Flood Control Project Maintenance
Levee Inspections

Maintenance Issue Types Only, Levee Inspection Report By Mile - Spring 2017

Yolo County Service Area 6

Waterway	Bank	Unit Miles	Inspection Start/End	Inspector
Unit No. 01 Right Bank of Sacramento River at Knights Landing	Right	5.87	05/01/2017 05/01/2017	Zach Jojola

Photo 1 of 1 : SP_2017_NA0022_350_5_20170320_00006.jpg

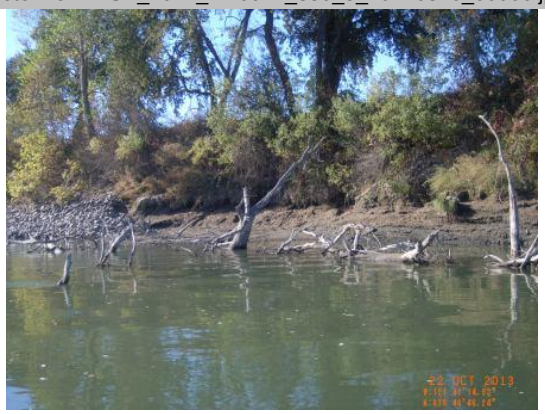
2006 - Short section is into the levee toe, rest is near the levee toe. Mass failure and fluvial erosion of depositional material. Rock at the upstream and downstream ends. 2011 - Minor new erosion. 2012 - Slope continues to steepen, tree roots have become exposed, and new eddy formed. 2015: No observed changes. [2015 Site ID: SAC_86-9_R]

Photo 1 of 1 : SP_2017_NA0022_350_3_20170320_00002.jpg

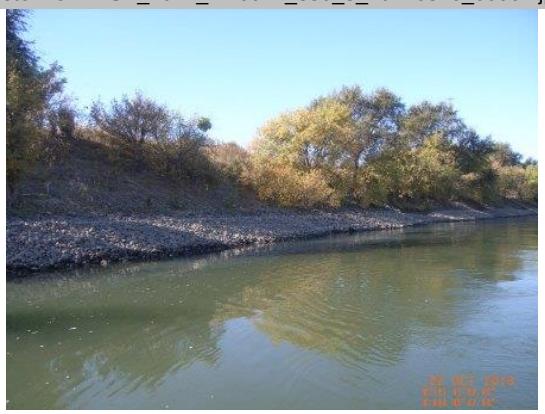
2009 - Erosion into the levee toe. Some cobbles have been dumped into the erosion pockets. 2010 - Old cobble site starting to unravel. 2012 - Slope continues to steepen and new animal holes. 2013 - Downstream cobble is unraveling. 2015: No observed changes. [2015 Site ID: SAC_85-4_R]

Photo 2 of 3 : SP_2017_NA0022_350_4_20170320_00004.jpg

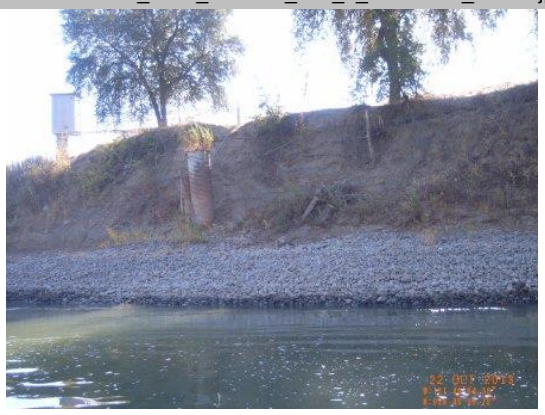
LM Start	**5.67**	Rating **	M	Issue No.	**4 (cont)**
LM End	**5.85**	Issue Type +	Ma	Location *	WS
